**DOCUMENT 00901
ADDENDUM No. 1**

1. This Addendum applies to the following project: Upgrades to Pump Station "A" & "B". Please add Document 00901 – Addendum No. 1 to the Contract Documents & Specifications for this project.
2. Revise Document 00003 – Table Of Contents of the Contract Documents & Specifications to include the following:
 - i. Document 00901 – Addendum No. 1.

PUMP STATION "B" ELECTRICAL DIAGRAM
NOT TO SCALE

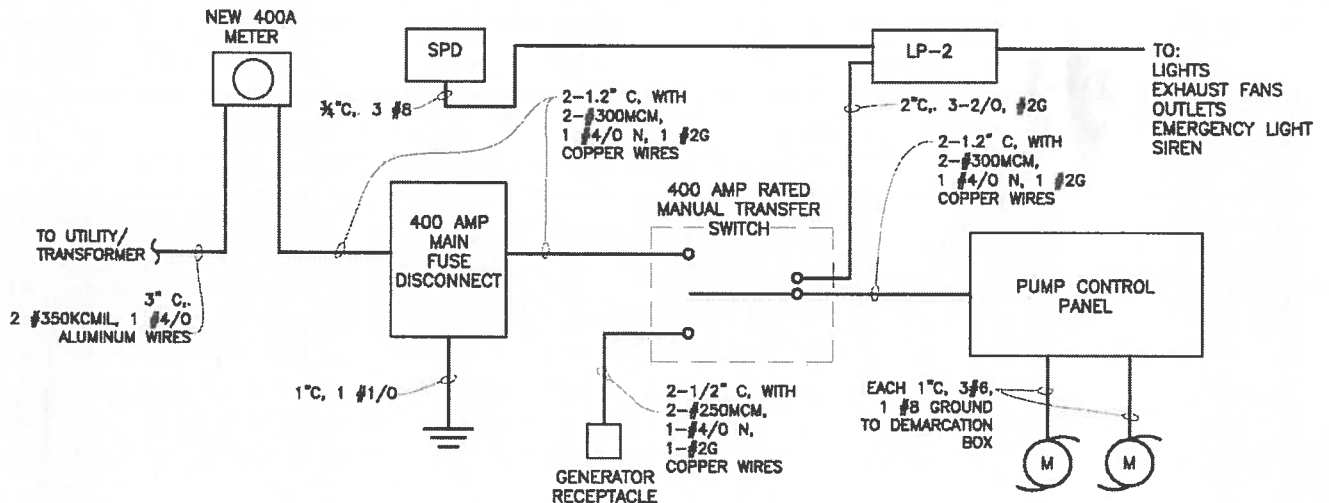
3. Sheet 8 of 10 of the Contract Documents shall be modified as follows:
- Modify "Relocated Generator Plug" labeled leader to read "New Crouse-Hinds 200 amp Reverse Service Generator Receptacle to match existing Town of Edisto Beach 200 amp generator Plug".
4. Sheet 10 of 10 of the Contract Documents shall be modified as follows:
- Replace Pump Station "B" Electrical Diagram detail with the following Pump Station "B" Electrical Diagram detail:
